# RECALL R22CB-C:

## 7.3L SHIFT CABLE-GASOLINE FUEL LINE INTERFERENCE

**Models Affected:** Certain 2022 & 2023 Model Year Blue Bird Vision Buses equipped with 7.3L Gasoline engine

Fig 1

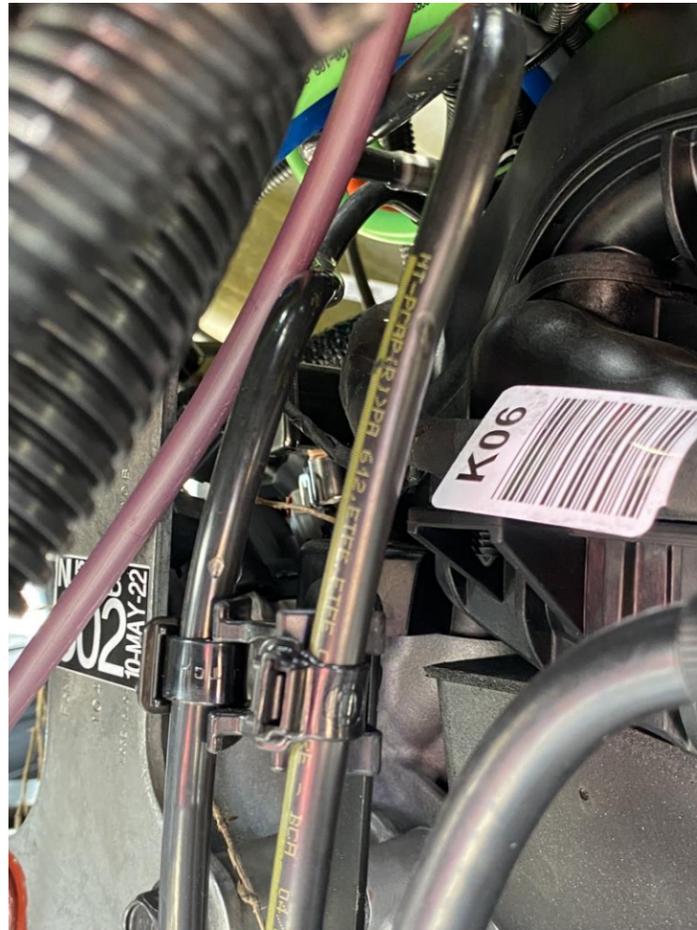
Step 1: Inspect the left rear corner of the engine from the top, and the bottom. If there is greater than 3” of clearance between the shift cable and the fuel line, no further action is required. Ref. Figure 1 for an example of insufficient clearance. If <3” of clearance, proceed to step 2.

Fig 2

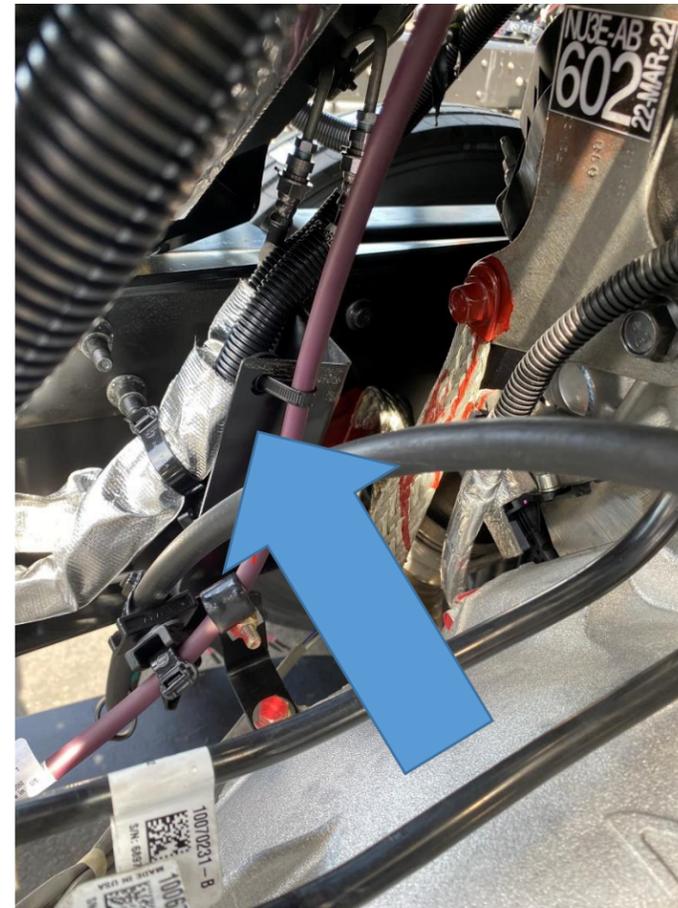
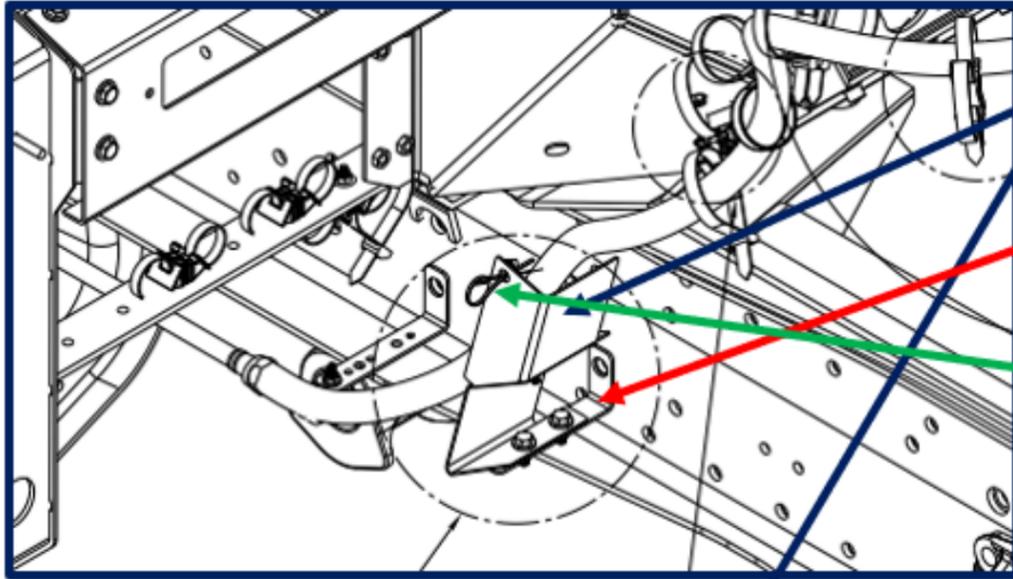
Step 3: Verify the heat shield bracket (Item 2), regardless of brake type is in place. Reference Figure 2. If missing, install per Figure 3.

Fig 3

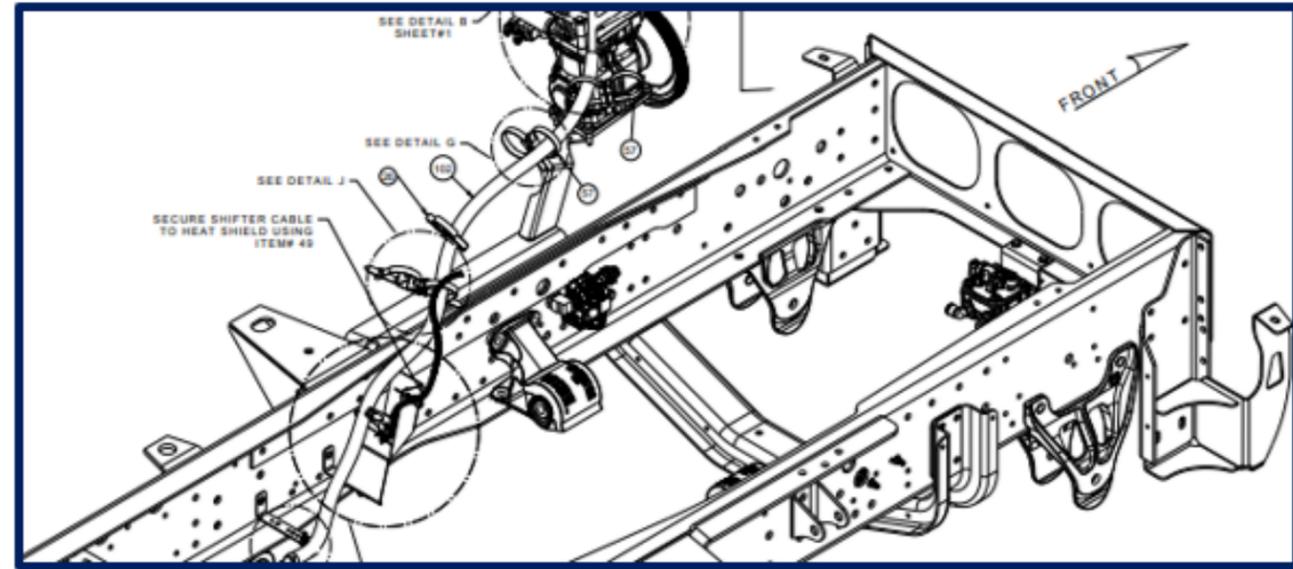
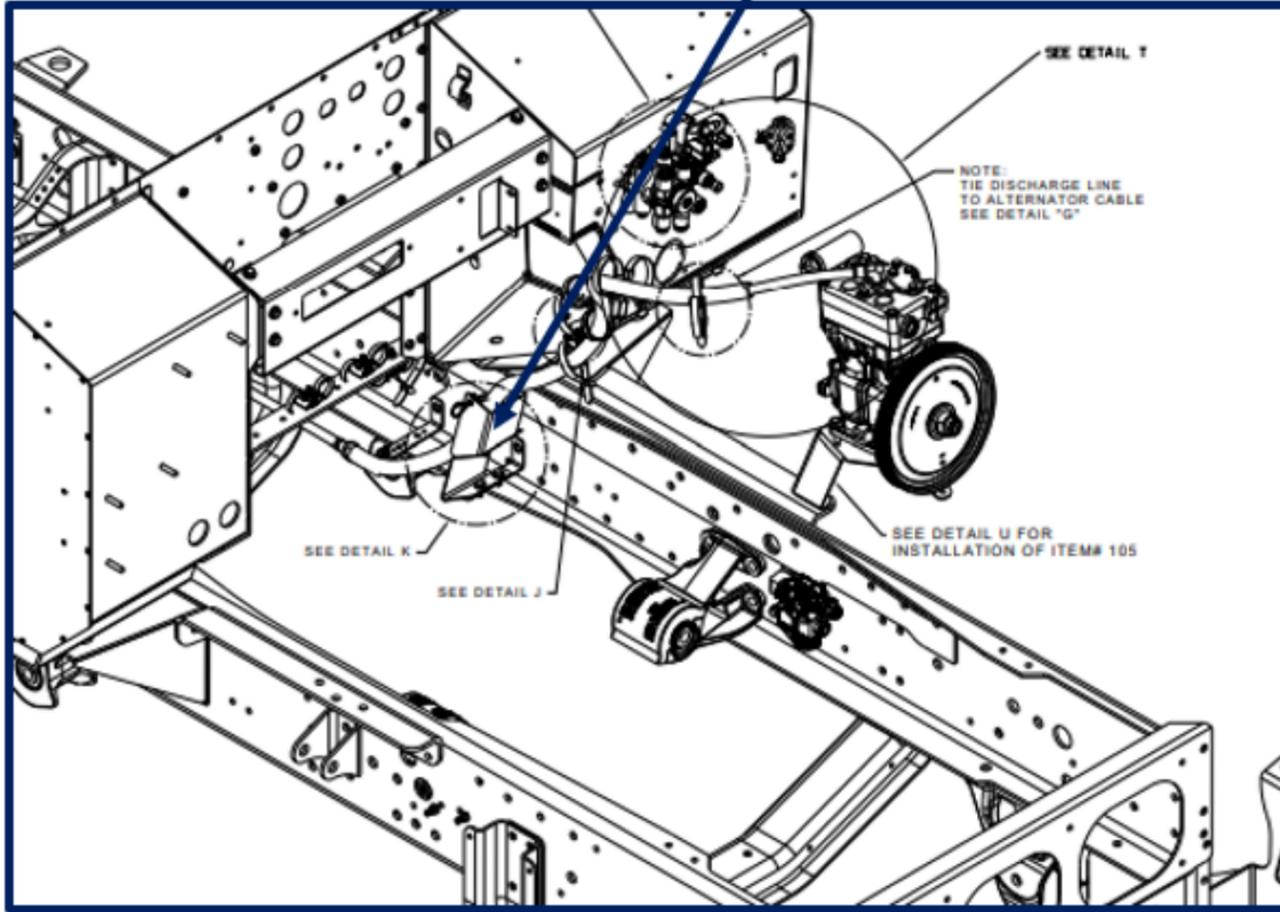
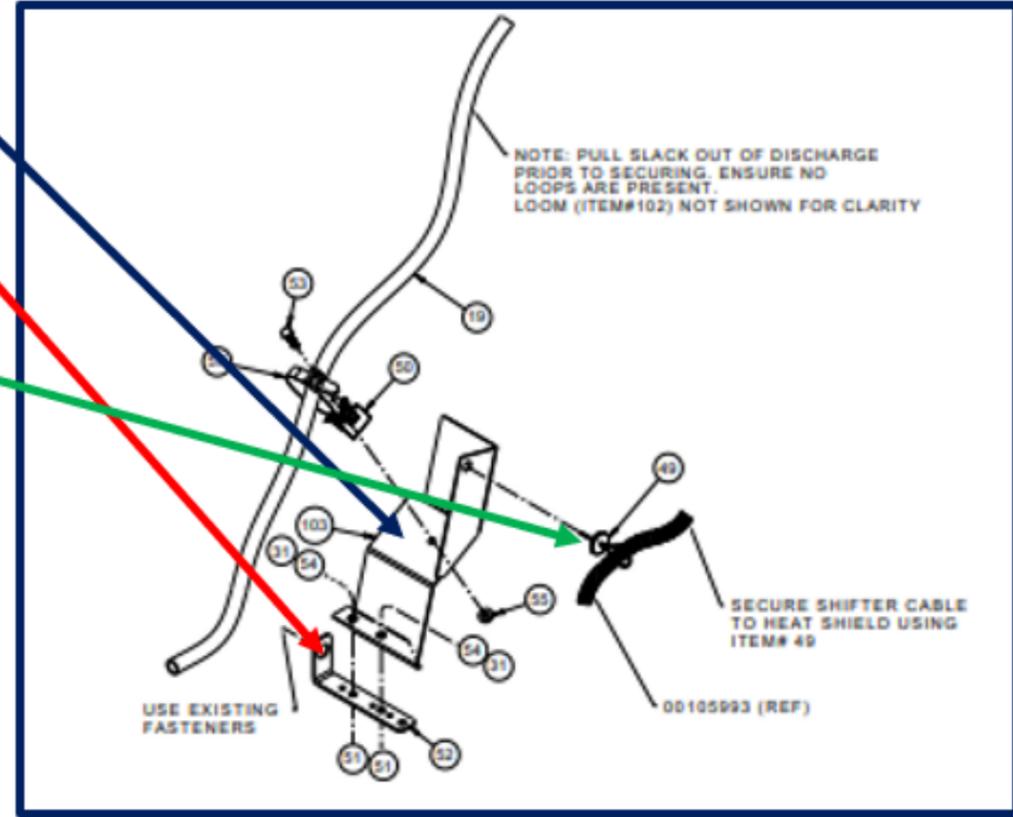
Step 4: Verify shift cable is routed properly and secured to the bracket with the HD button cable tie, p/n 00024076 per Figure 3

Fig 4

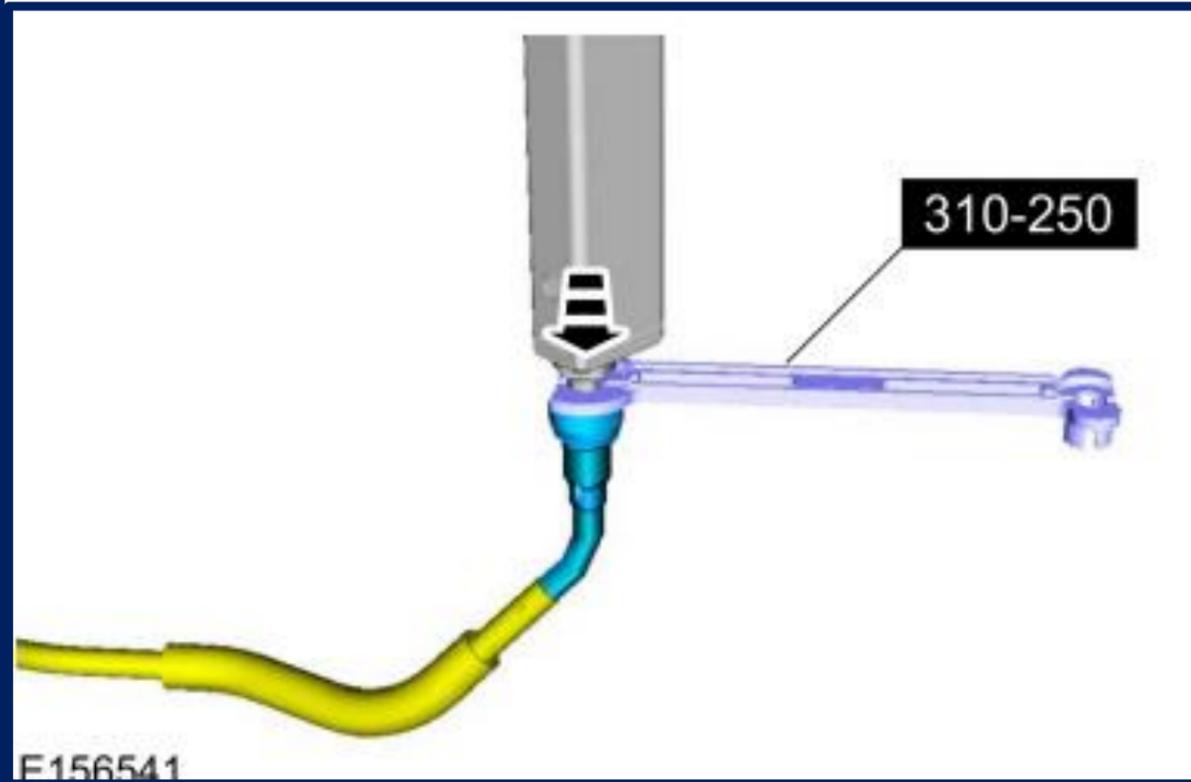
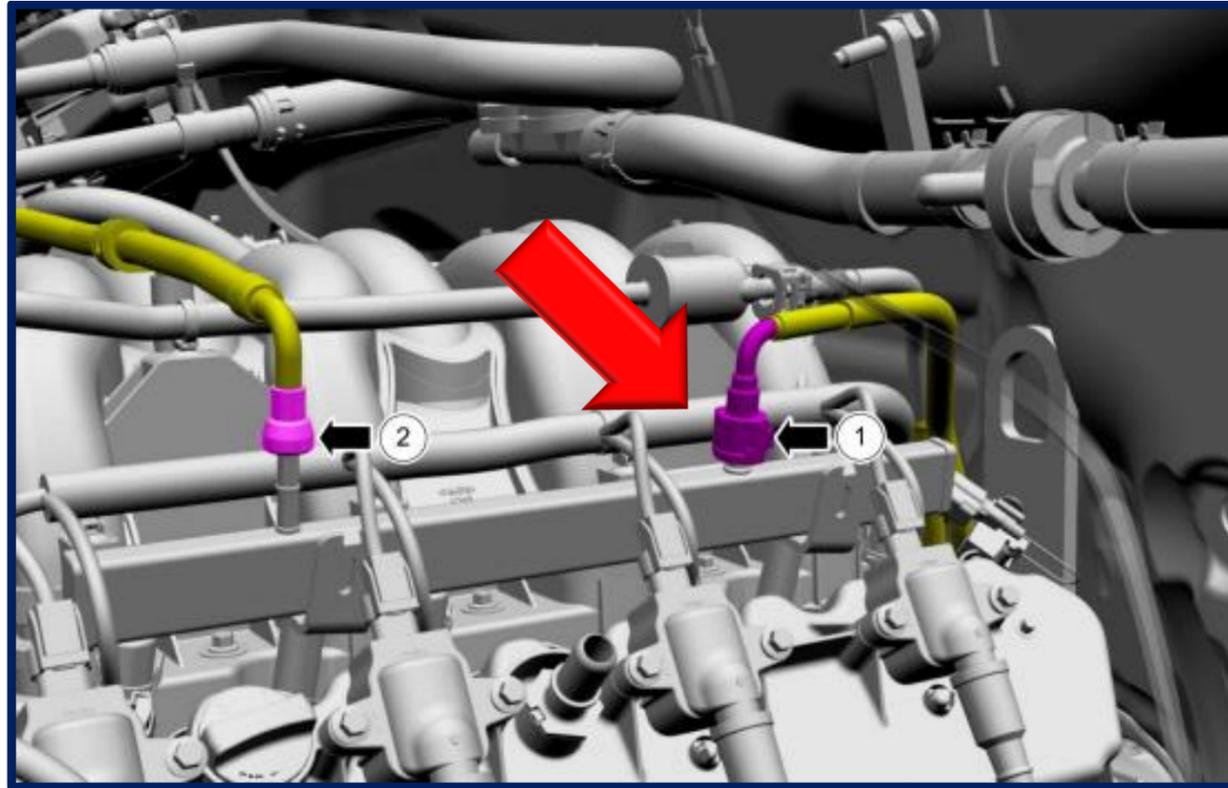
D- Wearing appropriate PPE, lay an absorbent cloth below the fuel line connection at the fuel rail and slowly disconnect the fuel line using Rotunda 310-250 or equivalent. See Figure 4
